SAN ANTONIO WATER SYSTEM
Interdepartment Correspondence Sheet

Subject: Zoning Case Z2016040 (S & A Management Multi-Family)

Date: December 18, 2015

ZONING FILE: S & A MANAGEMENT MF (FIGURE 1)
ZONING CASE: Z2016040
MAP GRID: 131, F5

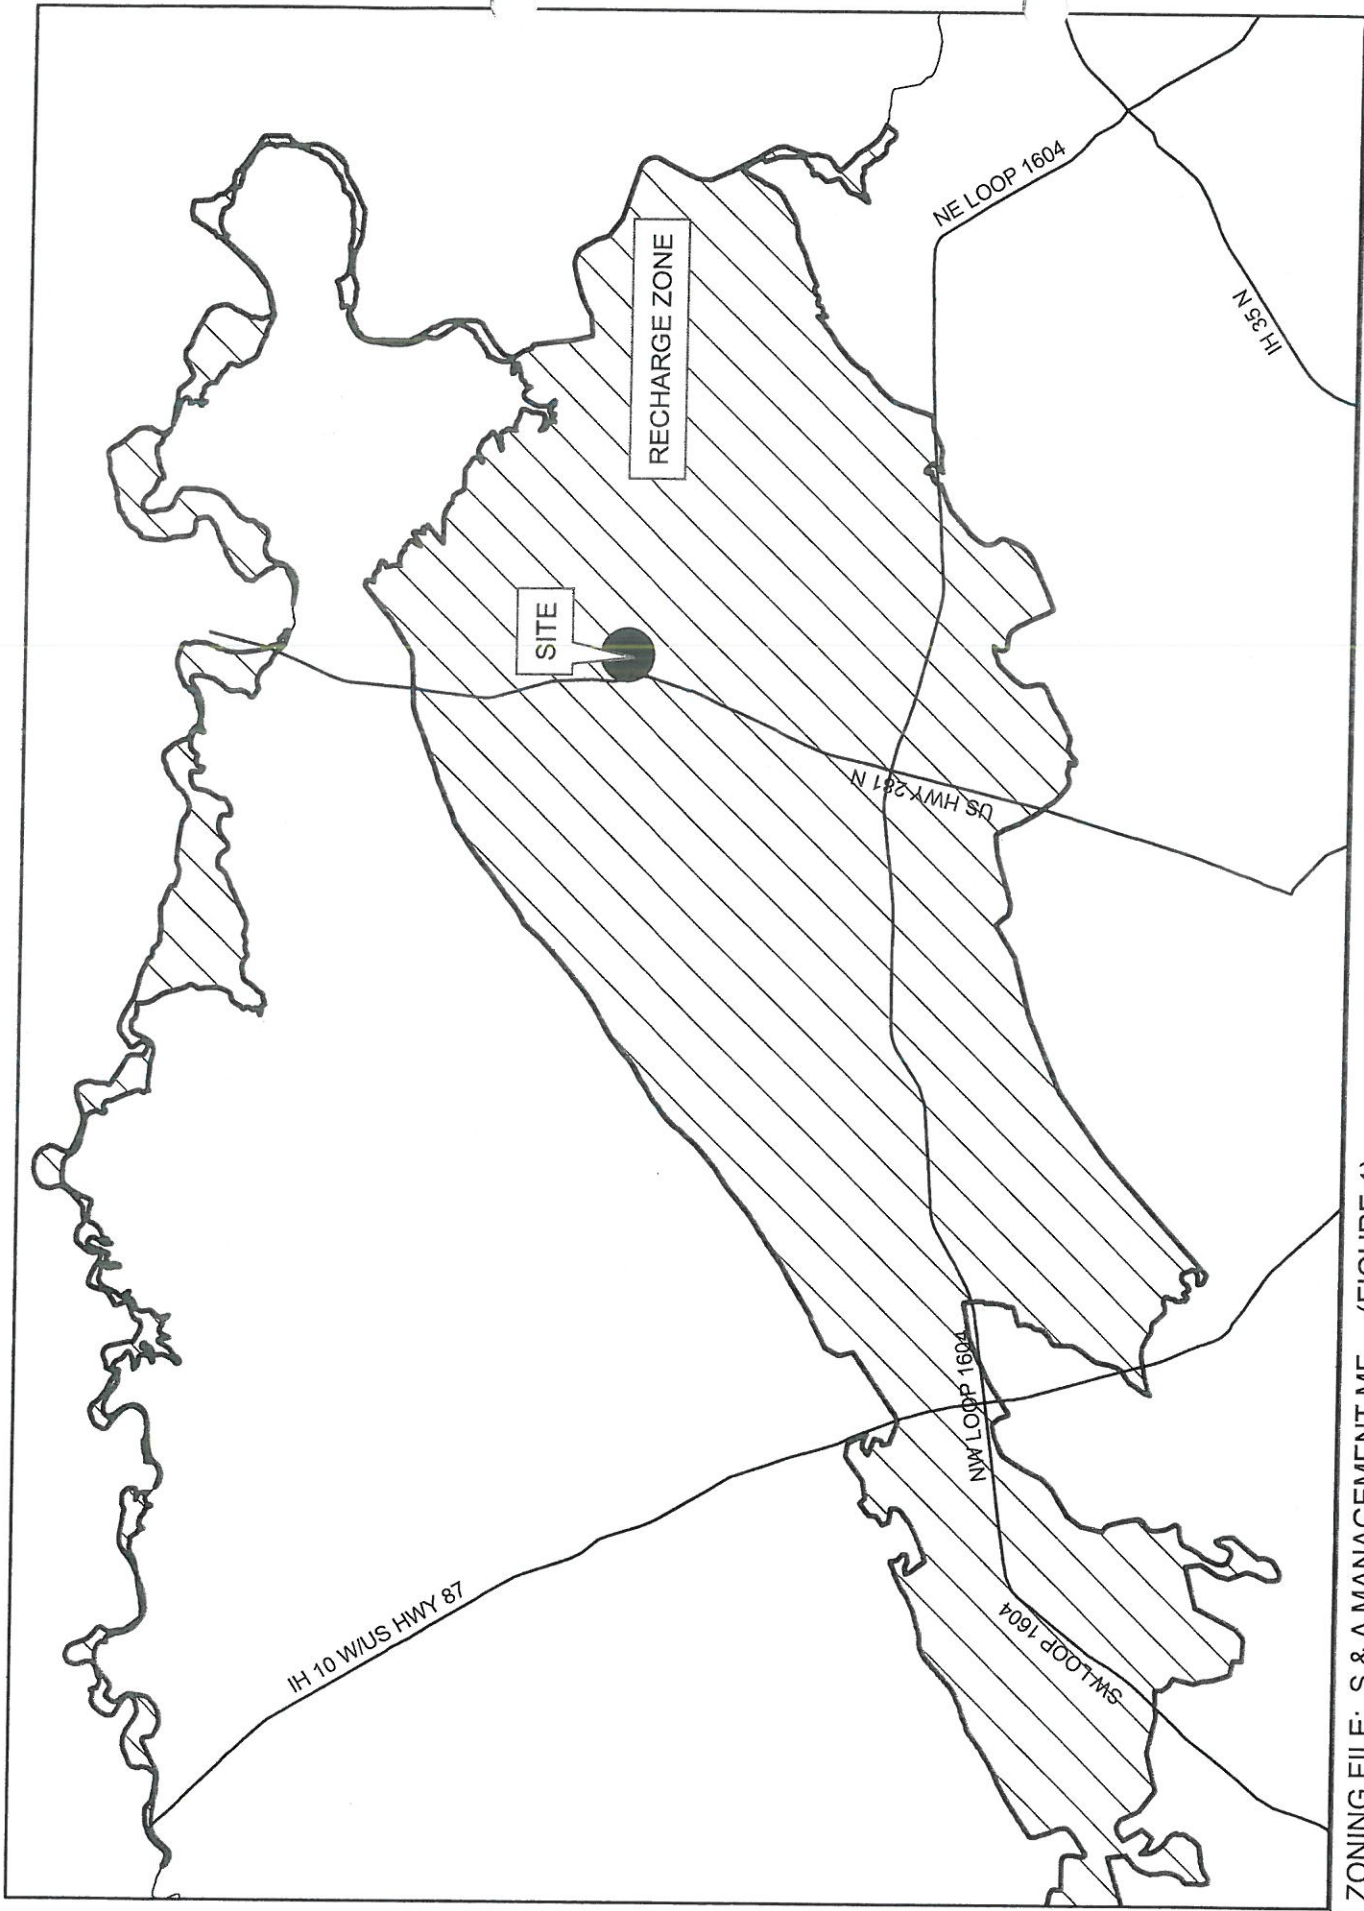
The subject property is located in City Council District 9, approximately 1,305 feet south of Marshall Road on U.S. Highway 281 North. The property lies within the Edwards Aquifer Recharge Zone (Figures 1 and 2).

The subject site was observed to be one lot, currently undeveloped and moderately vegetated, approximately 10.673 acres in area. The site appeared to slope to the south and southwest. Stormwater occurring on the subject site would drain to the south and southwest into an unnamed tributary to West Elm Creek.

Using U.S. Geological Survey Water-Resources Investigations Report 95-4030 it was determined that the subject site is underlain by the Kirschberg Evaporite Member of the Kainer Formation throughout the northern portion of the site, and is underlain by the Dolomitic Member of the Kainer Formation throughout the southern portion of the site.

No sensitive geologic features were identified within the subject site.

1. The impervious cover shall not exceed 50% on the site.
2. The land uses within the project site shall be in conformance with the table of permitted uses at the time the re-zoning is approved. Should a proposed use be listed as requiring City Council approval, the owner/operator shall apply for re-zoning for that particular use at the project site. If the land use is listed as special use, a special permit must be obtained for that use. If the land use is listed as not allowed, that land use will not be permitted on the project site.
